DCP/NRC1226  
NSD-NRC-98-5537  
Docket No.: 52-003

SUBJECT: AP600 RESPONSE TO FSER OPEN ITEMS

Enclosure to Westinghouse  
Letter DCP/NRC1226

Figure 3.8.5-3 (Sheet 5 of 5)

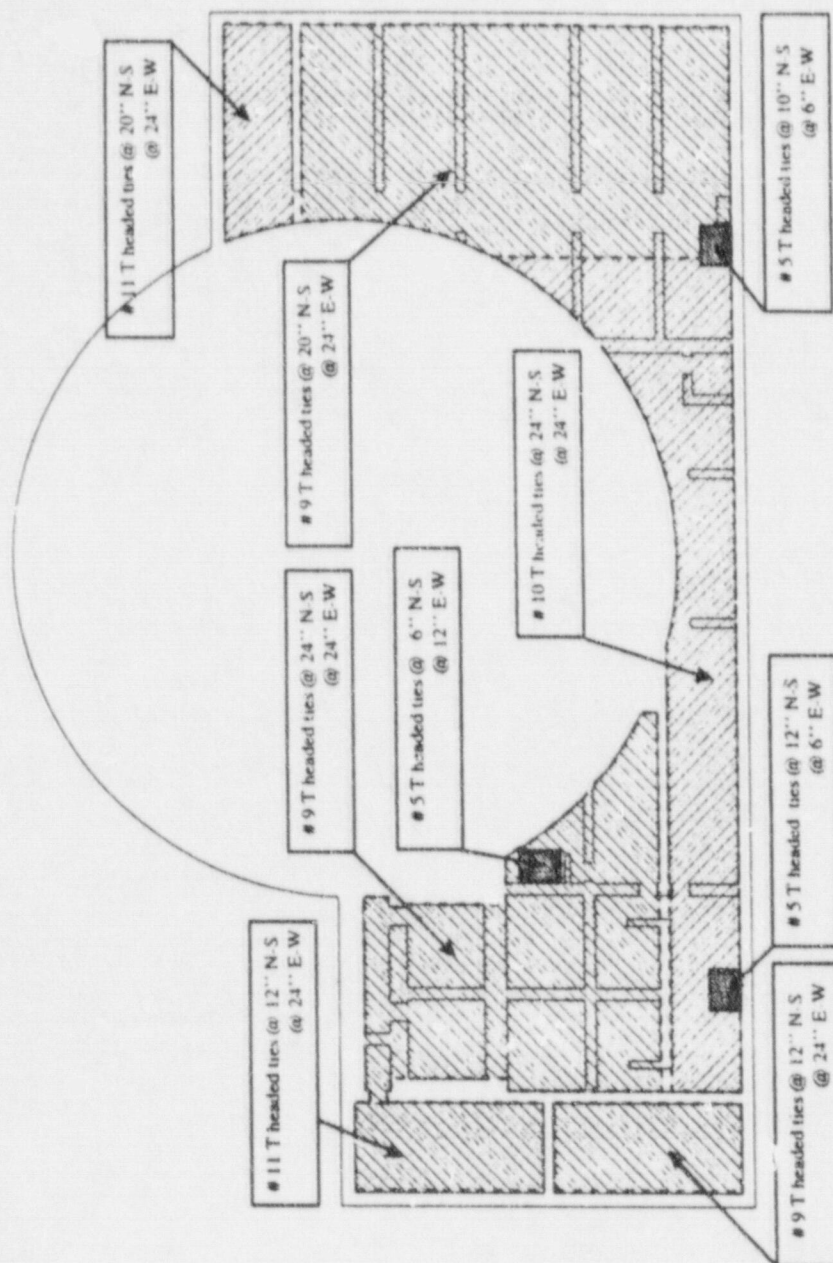
During the meeting conducted on August 4 through 15, 1997, the staff reviewed the final design of the 6-foot thick foundation mat. As a result, based on the commitment made by Westinghouse in SAR Section 3.8.4 (Revision 15) that (1) the design and analysis procedures for SC-I structures are in accordance with ACI-349 Code for reinforced concrete structures, and (2) the ductility criteria of ACI 318 Code, Chapters 12 and 21, are considered in detailing, placing, anchoring and splicing of the reinforcing steel, three design concerns were identified by the staff:

1. According to Chapter 21 (Section 21.3.3.4) of ACI 318-95 Code, stirrups used as shear reinforcement have to be provided with a 135 degree hook at both the top and bottom faces of the foundation mat. However, only stirrups, with 90 degree hook at the bottom face and 135 degree hook at the top face of the mat, were provided by Westinghouse for resisting shear force. The flexural steel is spaced at 6 inch on centers top and bottom. Therefore, the provision of 135 degree hooks is not practical. The 6 ft thick foundation mat does not appear to be constructible with such heavy reinforcements.

2. According to the ratio of span to depth, the NI foundation mat should be classified as deep flexural members and be designed for the requirements for deep flexural members (Section 11.8.1 of ACI 349-90). However, based on some test results, the ACI 318 Code Committee determined that errors were identified in the 1983 code (same errors were in the ACI 349 code, because the 349 code is based on the 318 code) and these errors could result in an unconservative design for deep flexural members. As a result, ACI 318-95 was revised to correct these errors. For the case of AP600 foundation mat with exterior and interior stiffening walls, the foundation mat should be classified as a continuous deep flexural members (Sections 11.8.1 and 11.8.3 of ACI 318-95). ACI-318-95 Code (Section 11.8.5) requires that the critical section for shear is to be located at 0.15 times the span length from the support edge with reinforcing steel over the full span and the design should be based on Section 11.8.3. However, Westinghouse did not treat the foundation mat as a deep flexural member. The shear reinforcement used in the design was based on a much reduced shear force at a section which is further away from the edge at a distance of the effective depth of the mat. The correct amount of shear reinforcement would require the use of larger reinforcing bars which would be spaced at a distance not more than " $d/2$ " throughout the length of the member.

3. The foundation mat calculation was performed using soil stiffness variation in alternate spans. While this design approach will maximize bending moments in the mid span, it will not indicate increases in shear force due to soil variation. If the soil variation is such that the soil stiffness is constant over two adjacent spans, and spans on either side are with lower or higher stiffness, the

maximum shear force will occur at the wall between the two spans with the greatest stiffness. This geometry was not considered in the Westinghouse design.

On the basis of the discussion above, the staff concluded that Westinghouse failed to demonstrate that the proposed foundation mat design is adequate with respect to the previously issued staff position. The final design of the foundation mat did not meet certain code requirements committed to in the SAR.

The top and bottom reinforcement in the east west direction of span are equal. The reinforcement provided is shown in sheets 1, 2 and 5 of Figure 3.8.5-3. Typical reinforcement details showing use of headed reinforcement for shear reinforcement are shown in Figure 3H.5-3.

- | *Revise Figure 3.8.5-3 (sheets 4 and 5 of 5) to show additional shear reinforcement.*

Figure 3H.5-3

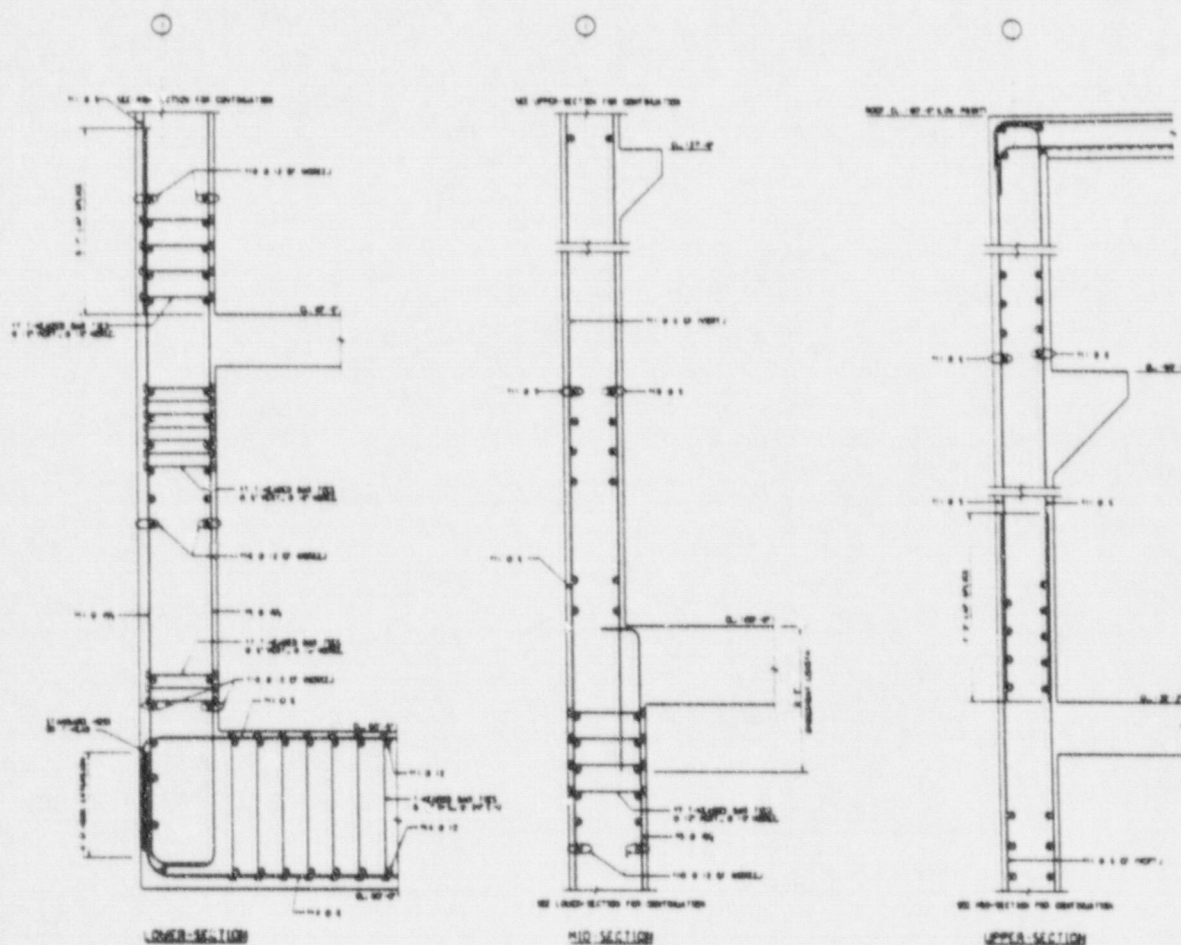
For the concern of seismic hooks used for the shear reinforcement (Item 1 above), Westinghouse proposed the use of headed anchors (instead of 135 degree bends) at both ends of the shear reinforcement (stirrups) during the meeting on August 4 through 8, 1997. Westinghouse also provided, in the meeting, test results published by the manufacturer for the staff review. As a result, the staff found that the shear reinforcement with headed anchors is equivalent to the use of 135 degree bends at both ends of the shear reinforcement and concluded that this issue is technically resolved. However, Westinghouse should document this commitment in a future revision of the SAR.

On the bases discussed above, the staff concluded that the concern regarding the design of shear reinforcement for the foundation mat is technically resolved. However, Open Item 3.8.5-9 will not be closed until Westinghouse formally revises the SAR to document its commitments concerning the use of headed anchors for shear reinforcement and the commitments contained in the submittal dated November 24, 1997.

The use of shear reinforcement with headed anchors is documented in the SSAR revision shown below. The change in design criteria for the design of the basemat as a deep slab was included in SSAR subsection 3.8.5.5 in Revision 18.

Headed reinforcement meeting the requirements of ASTM A970 (Reference 49) is used where mechanical anchorage is required, such as for shear reinforcement in the nuclear island basemat and in the exterior walls below grade.

*Add Figure 3H.5-3 - also included in response to FSER Open Item 220.128F.*
